FINAL PLAT
SPOTSWOOD ADDITION
TO SEDGWICK COUNTY, KANSAS

RE: SUB 2001-49 -- One-Step Final Plat of Spotswood Addition

CASE NUMBER: SUB 2001-49 -- SPOTSWOOD ADDITION

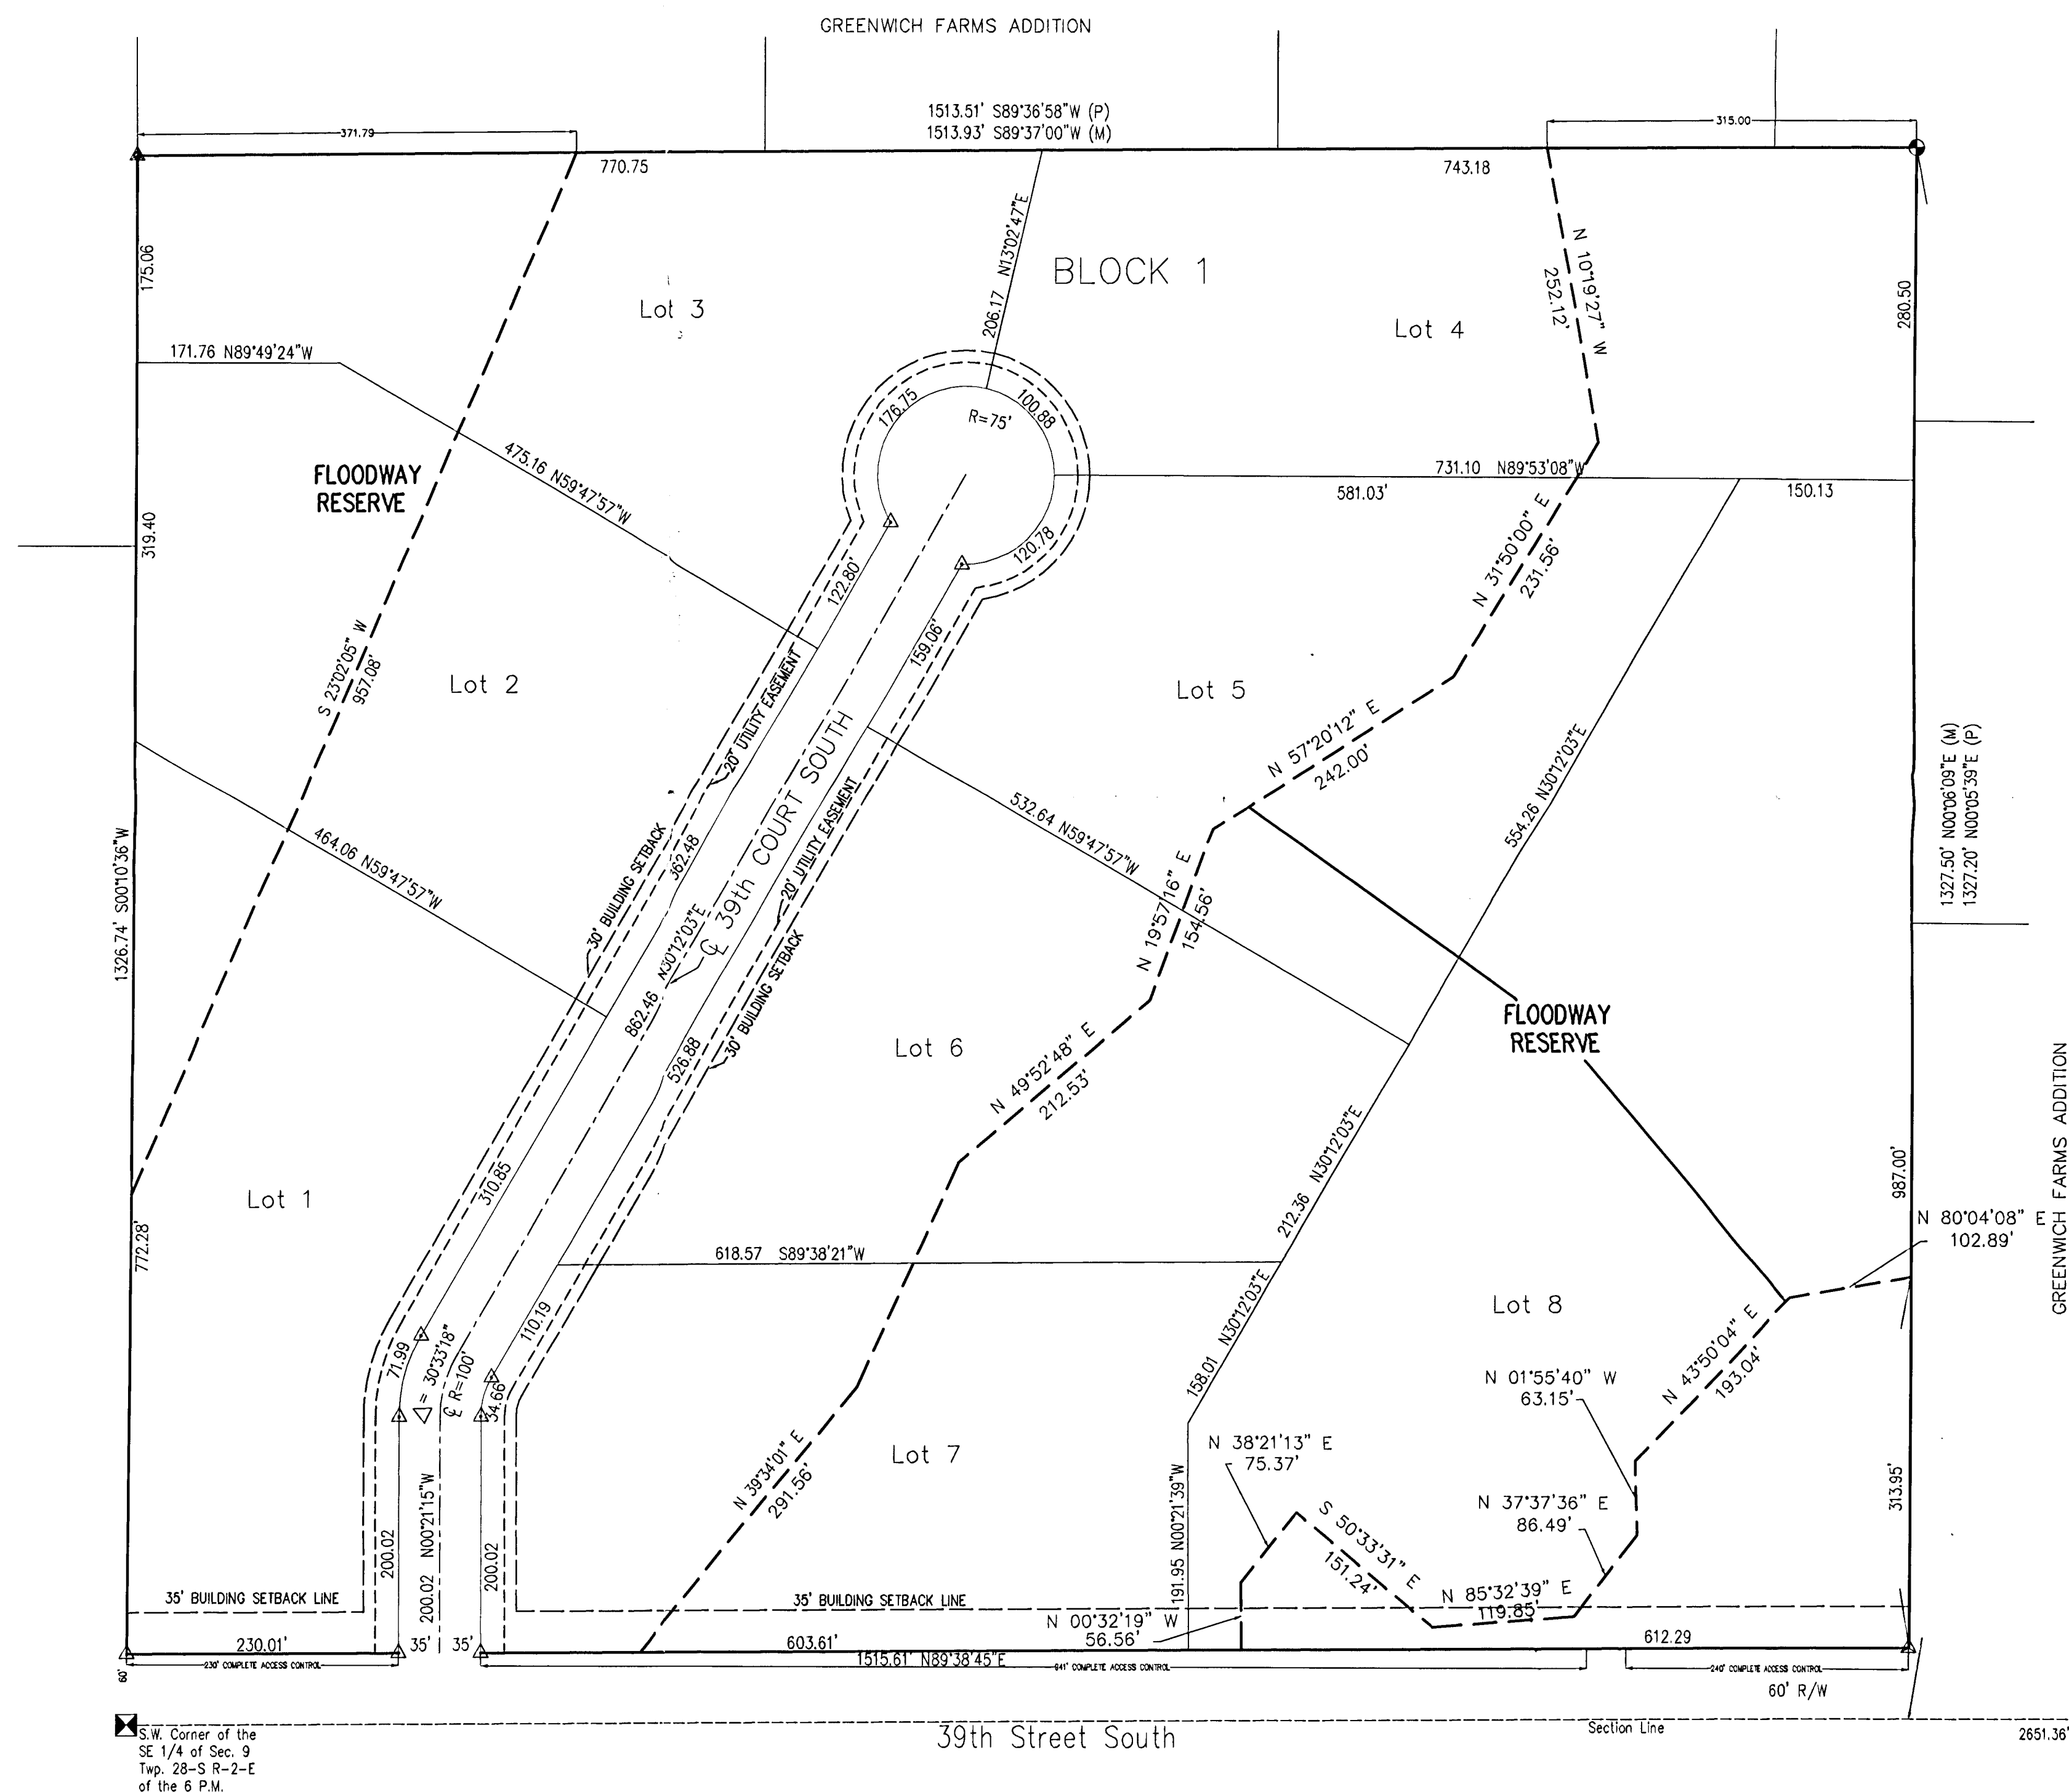
- D. County Engineering needs to comment on the status of the applicant's drainage plan. The drainage plan is approved. A flood study is required. A minimum pad elevation needs to be established. A drainage reserve is required between Lots 6 and 7.

- G. The diameter of the turnaround should be increased to 150 feet to conform with Subdivision Regulations.
- H. County Engineering needs to comment on the access controls. The plat proposes one access opening along MacArthur Road for Lot 1, Block 2. One opening is approved.

- I. The plat shall be included within one block. Lot 1, Block 2 should be labeled as Lot 8.
- J. The applicant shall guarantee the installation of the proposed street to the 36-ft rock suburban street standard. County Fire Department has required that the street be installed prior to the issuance of building permits.

- M. On the final plat tracing, the MAPC signature block needs to reference "J.D. Michaelis, Acting Chair".
- N. The County Commissioners signature block needs to only reference the Chair.

- O. The applicant is advised that if platted, the building setbacks must be 35 feet along MacArthur Road to conform with the Zoning setback standard for County section line roads.

- P. Approval of this plat will require a waiver of the lot depth to width ratio for Lot 4, Block 1. The Subdivision Regulations state that the maximum depth of all residential lots shall not exceed 2.5 times the width. The Subdivision Committee has approved the modification.

- Q. The County Fire Department needs to comment on the plat's street names. County Fire Department has recommended 39th Court South.
- R. The plat's text shall include language that a drainage plan has been developed for the plat and that all drainage easements, rights-of-way, or reserves shall remain at established grades or as modified with the approval of the applicable City or County Engineer, and unobstructed to allow for the conveyance of stormwater.
